**City of Ramsey**  
**Agenda**  
**Environmental Policy Board (EPB)**

Review Natural Resources Aspects of Hampton Townhomes Preliminary Plat

<b>DATE</b>	MAY 12, 2020	<b>PROJECT ADDRESS</b>	TBD
<b>PROJECT. TITLE</b>	HAMPTON HOMES		
<b>ESCROW #</b>	117171		
<b>DEPARTMENT:</b>	Planning Division (Landscape Plan & Environmental Resources)		
<b>TECHNICAL REVIEWER:</b>	Name: Chris Anderson Phone: 763-433-9817 Email: <a href="mailto:canderson@cityoframsey.com">canderson@cityoframsey.com</a>

<b>DATE</b>	MAY 12, 2020	<b>PROJECT ADDRESS</b>	TBD
<b>PROJECT. TITLE</b>	GARDEN VIEW VILLAS		
<b>ESCROW #</b>	117177		
<b>DEPARTMENT:</b>	Planning Division (Landscape Plan & Environmental Resources)		
<b>TECHNICAL REVIEWER:</b>	Name: Chris Anderson Phone: 763-433-9817 Email: <a href="mailto:canderson@cityoframsey.com">canderson@cityoframsey.com</a>

SHEET L1  
OF L4  
SHEETS  
4455.01

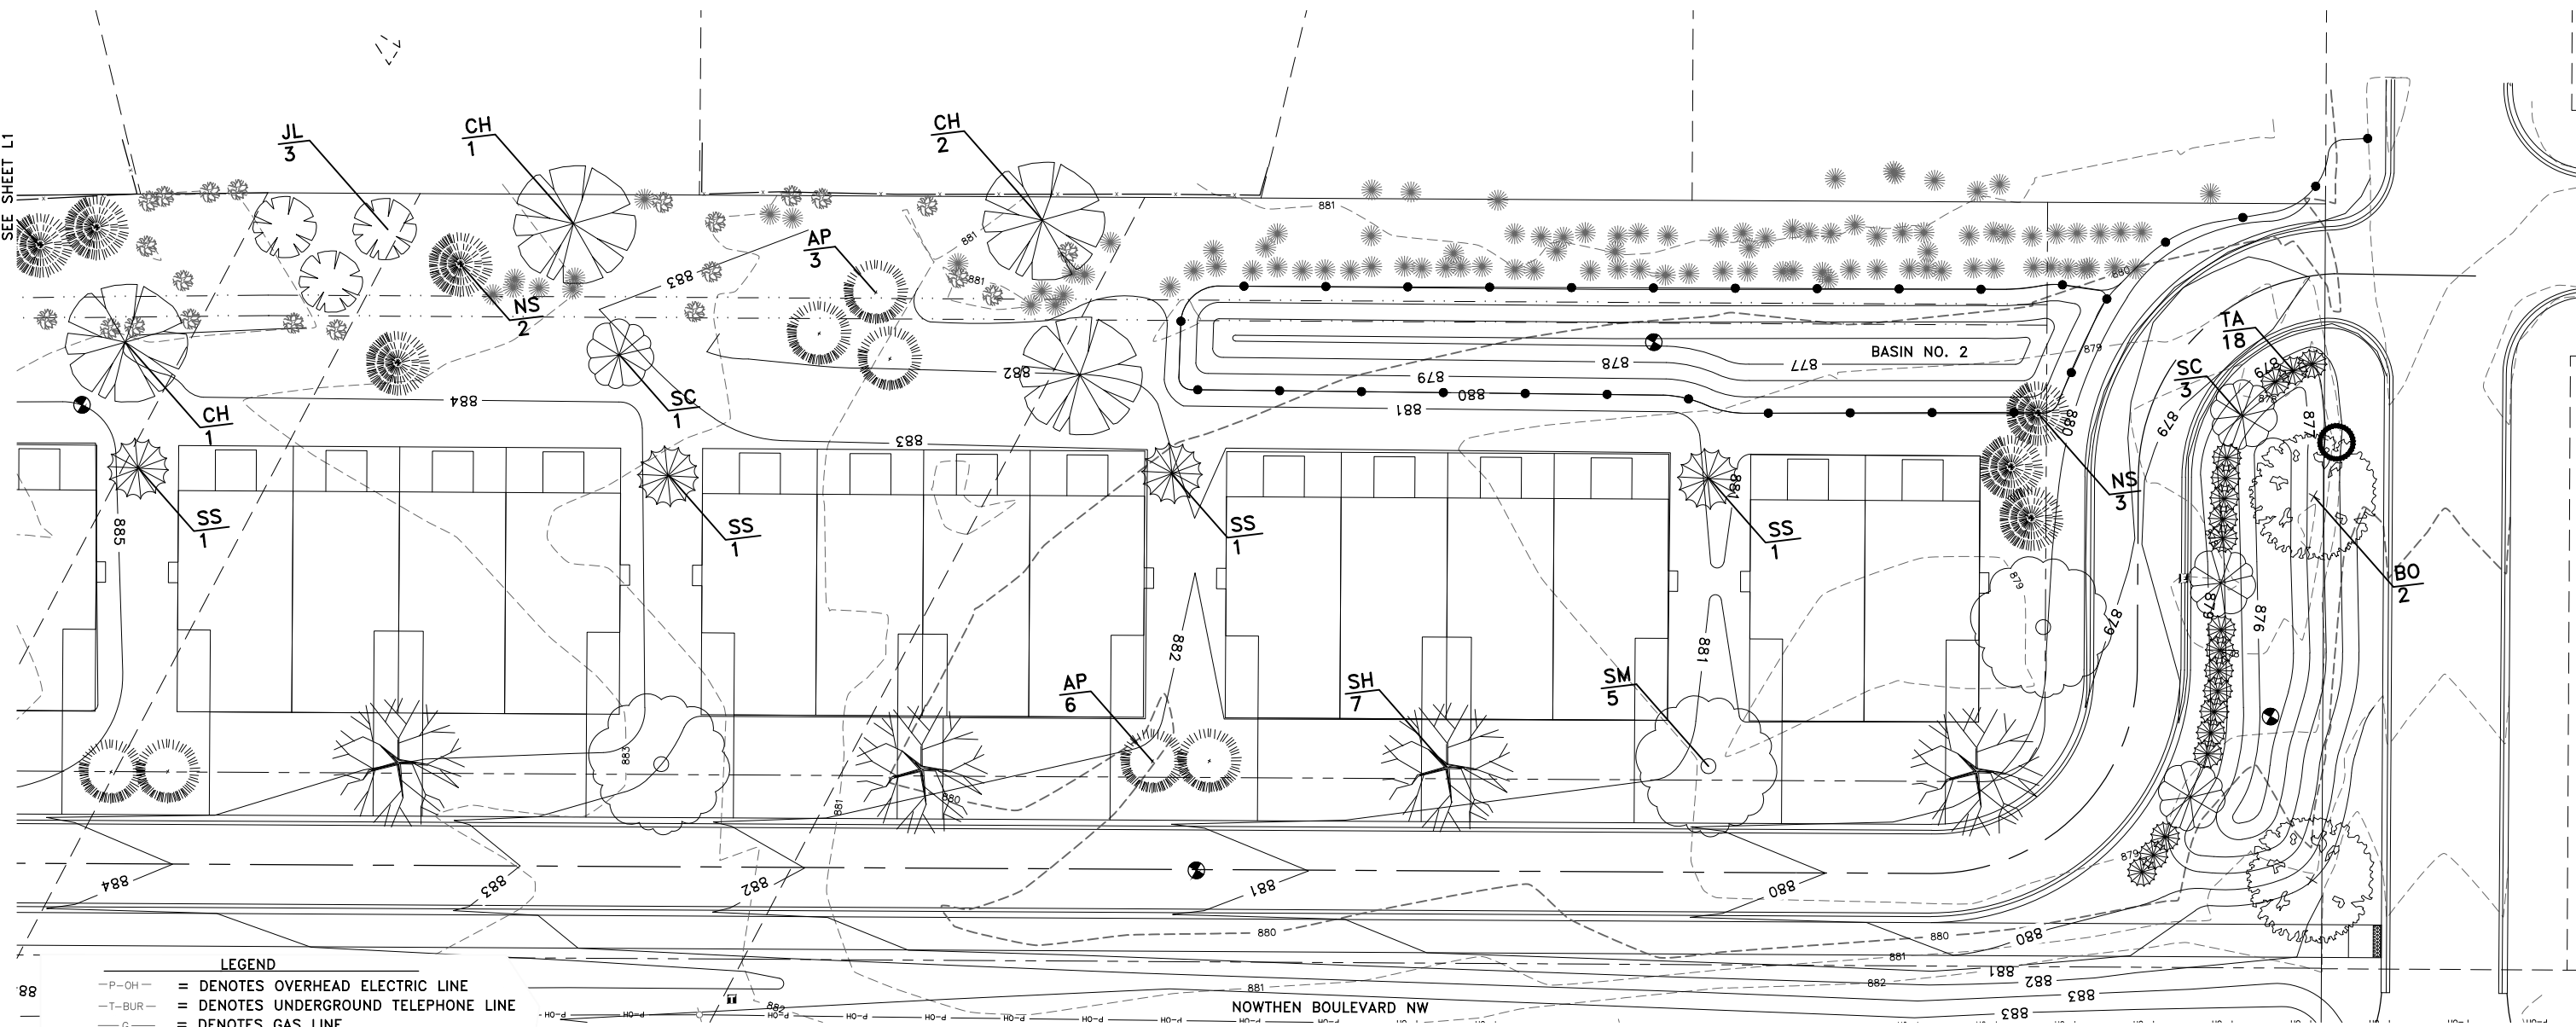
- Update sheet to specify where sod will be installed and any areas where seed is proposed.
- Sod is required within all boulevard areas (at least the first ten [10] feet back from street).
- Proposed trees along the western border (density transitioning plantings) need to have some shade tolerance as they will be interspersed with existing tree cover. Consider substituting in other, more shade tolerant species, along this border.
- Labels appear to be missing for the trees planted along the private road. Add labels.

SHEET L2  
OF L4  
SHEETS

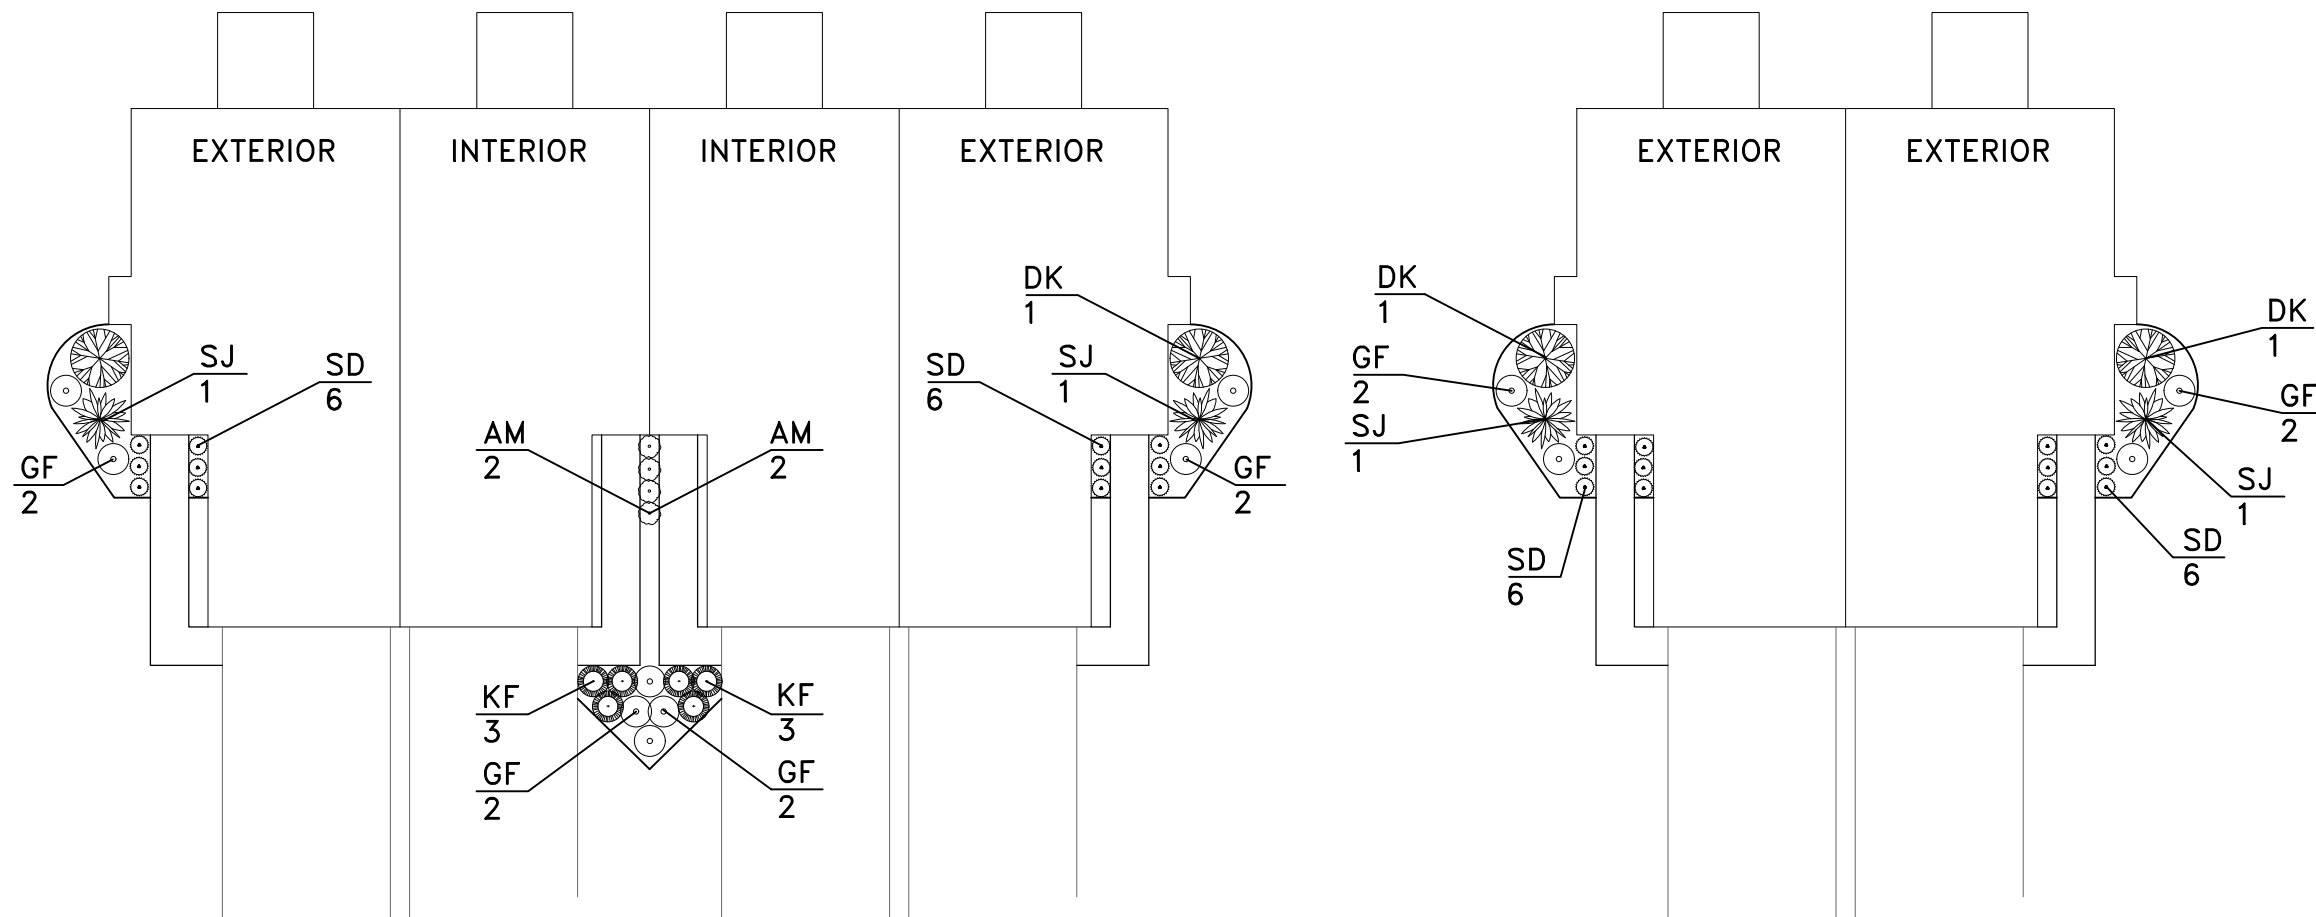
- Density Transitioning is required along the northern boundary of the site, which is approximately 187 feet in length (requires at least four (4) each of ornamental, evergreen, and overstory trees). Additional plantings must be added to this area.
- There is a small, bold circle next to one of the bur oaks along eastern boundary, what does that represent?
- The Spring Snow Crabapple and two Austrian Pines between the two northern most four-unit buildings should be relocated elsewhere on site. There is a storm sewer line that will run between these two buildings so it would be best to avoid any potential future conflicts with this infrastructure.

SHEET  
L4  
OF  
L4  
SHEETS

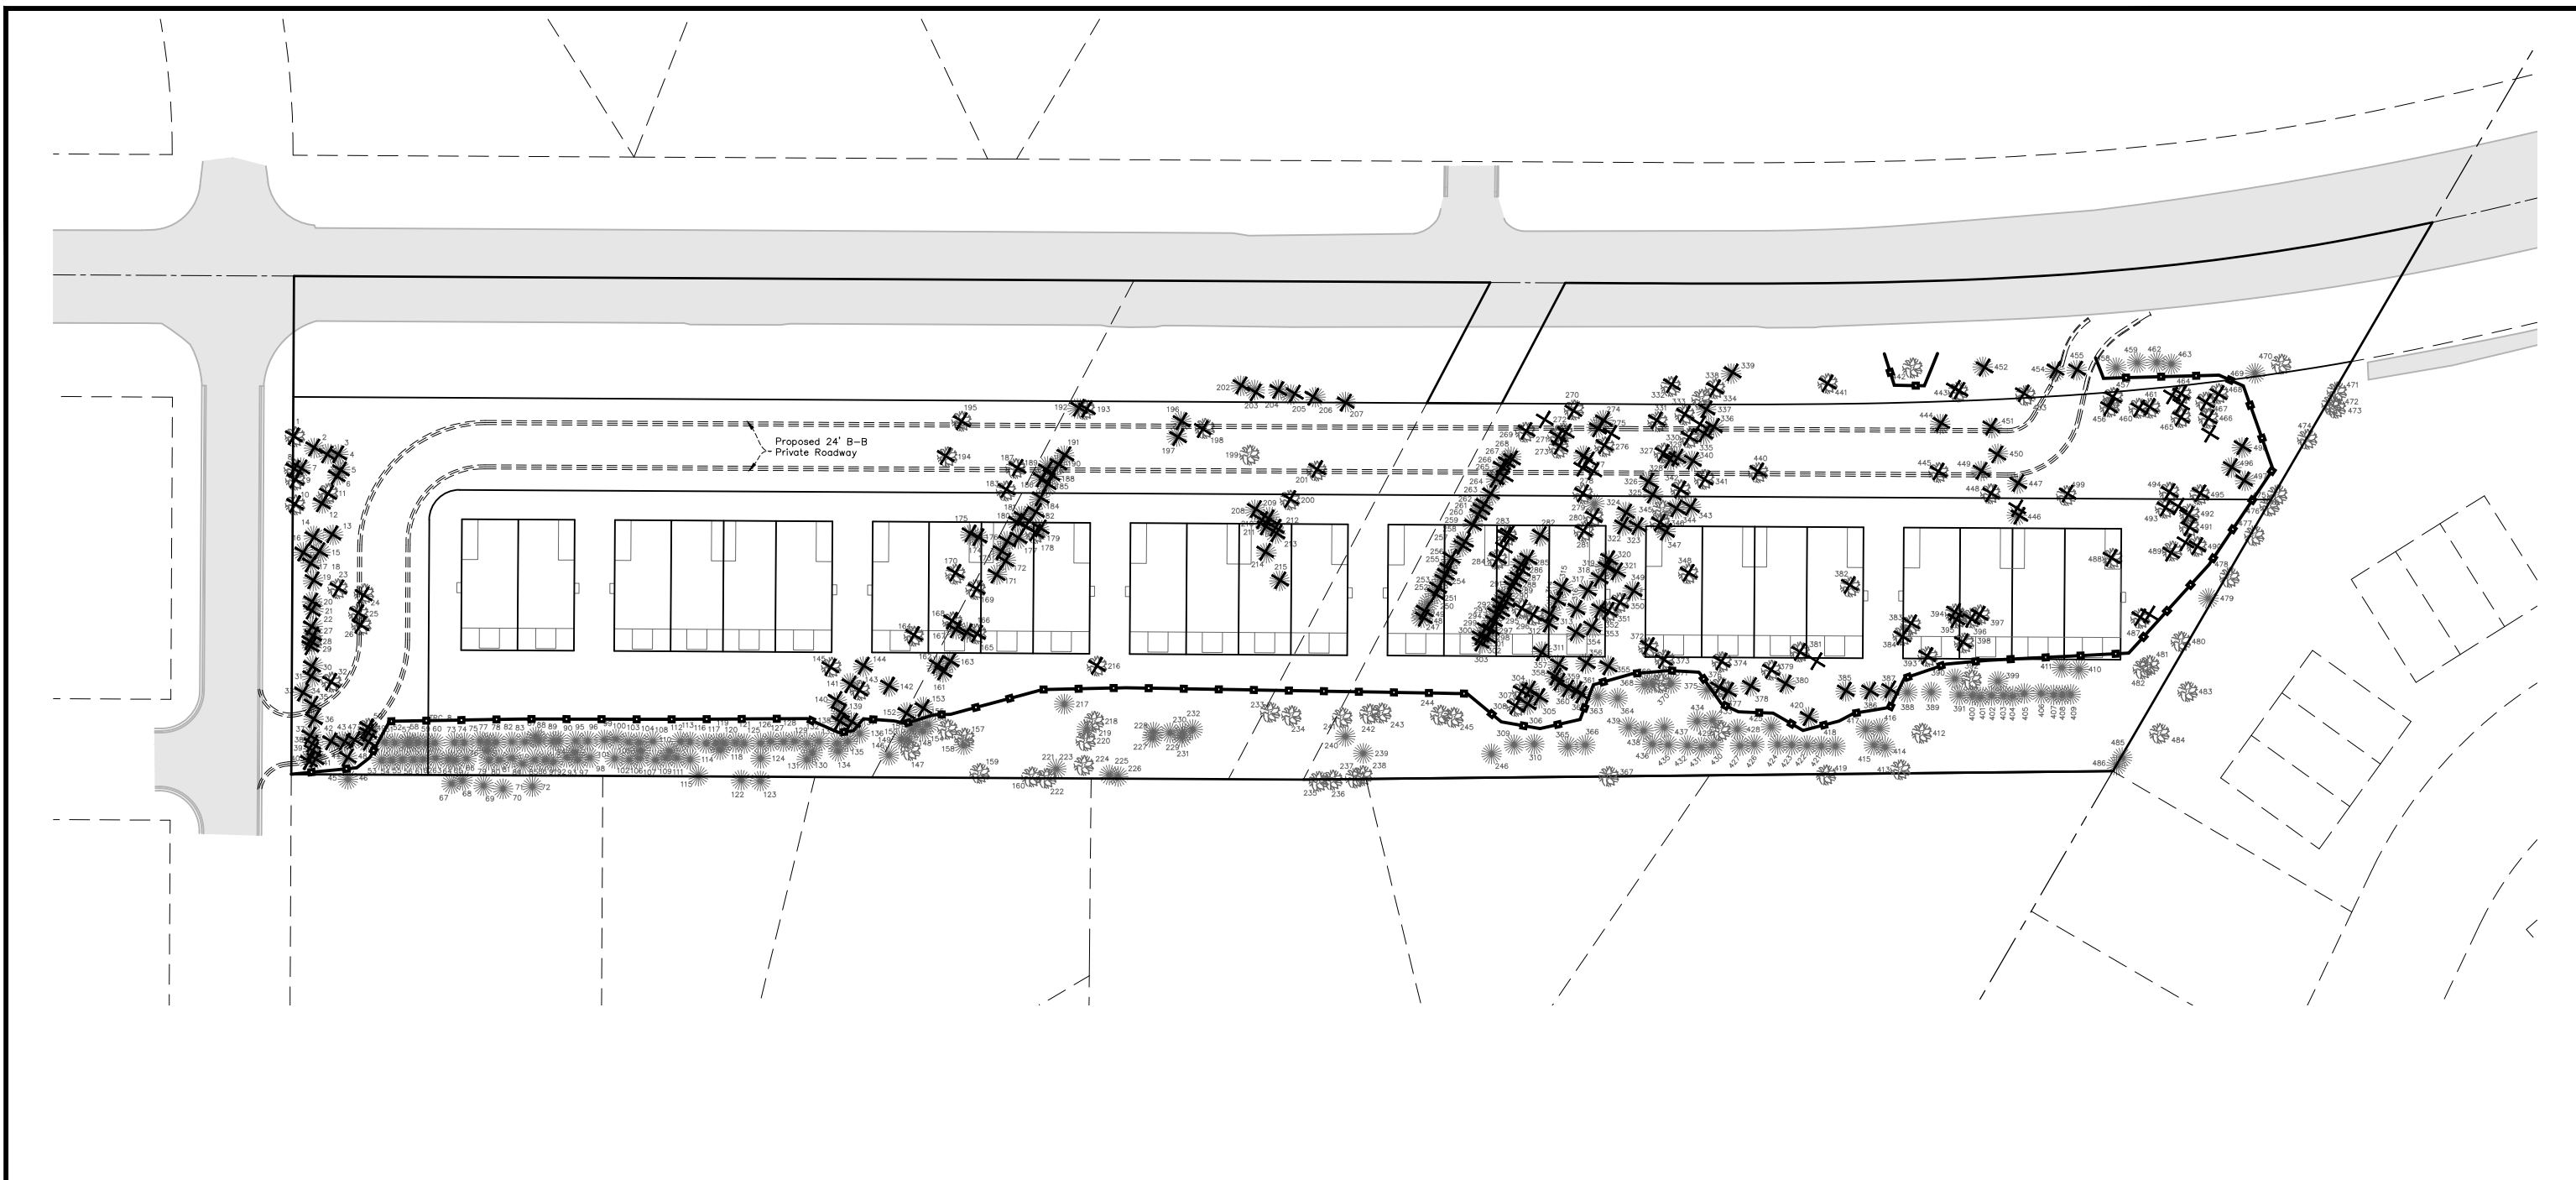
- Four (4) inches of topsoil, with not more than thirty-five percent (35%) sand content, is required over all disturbed areas not otherwise improved with impervious surfacing (e.g. buildings, driveways, walkways, etc.), excluding stormwater ponds.
- Irrigation system must include a rain sensor and some form of water efficient technology such as a smart controller. Add this language to Planting Notes.
- Change Plant List to specify minimum shrub size at installation is 24 inches in height or width, depending on species growth characteristics.

LANDSCAPE PLAN

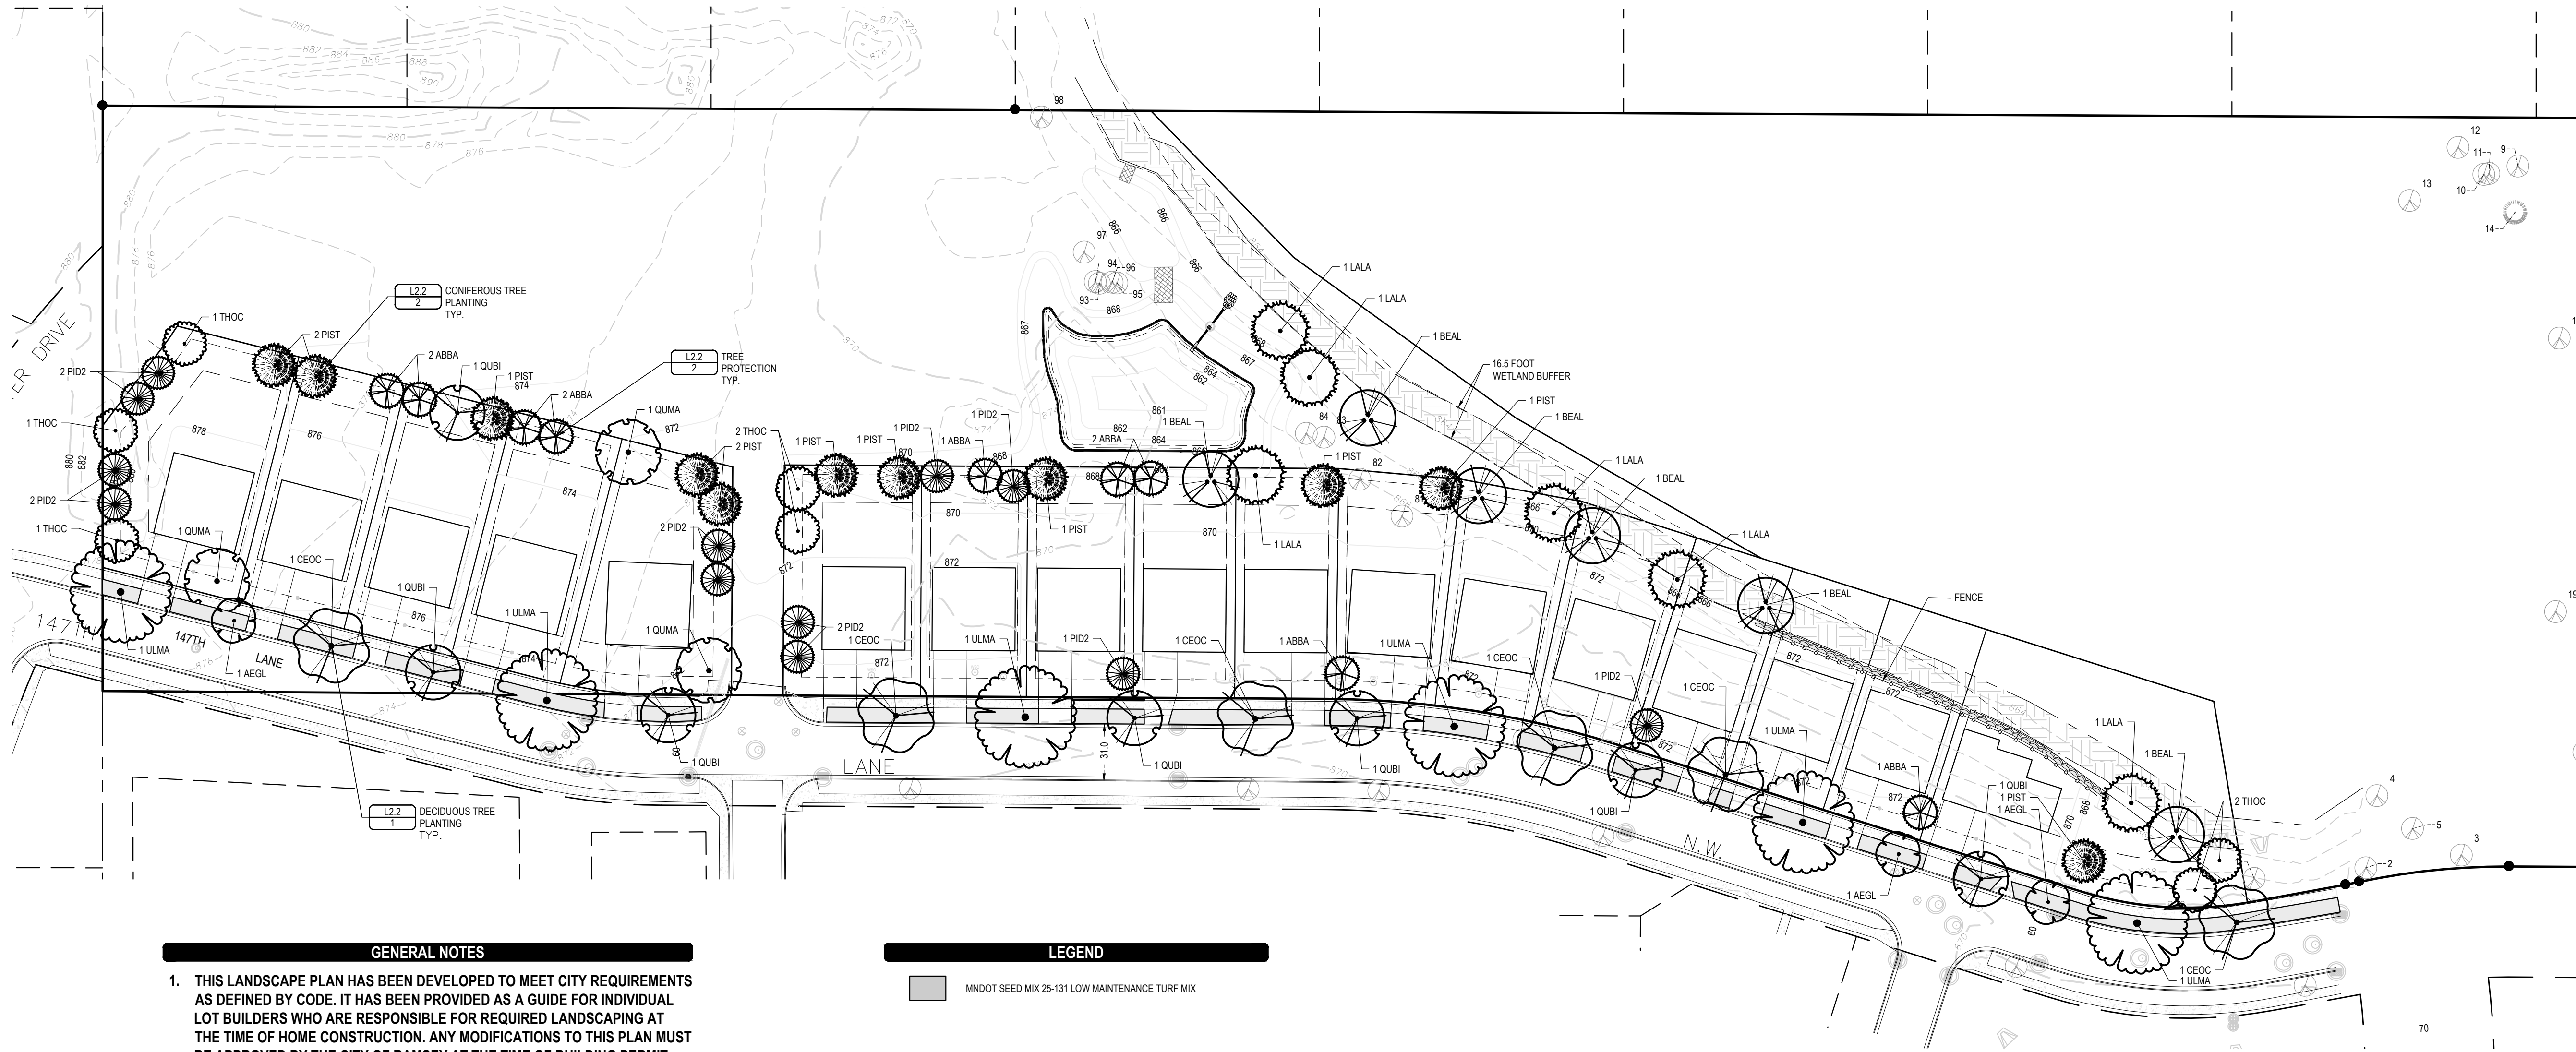
- Add column to Plant Schedule for total square footage per species.
- The General Note stating that builders are responsible for the landscaping must be amended. Trees within the front yard and boulevard area can be planted by individual builders, but perimeter plantings (including rear yards and side yards for certain lots) shall be the responsibility of the developer. The plantings per lot vary too greatly, which will create confusion for individual buildings (unless there will be a single, exclusive builder for the entire project).

- Developer shall also be responsible for any plantings within the outlot.
- A DED resistant cultivar of American Elm should be used.
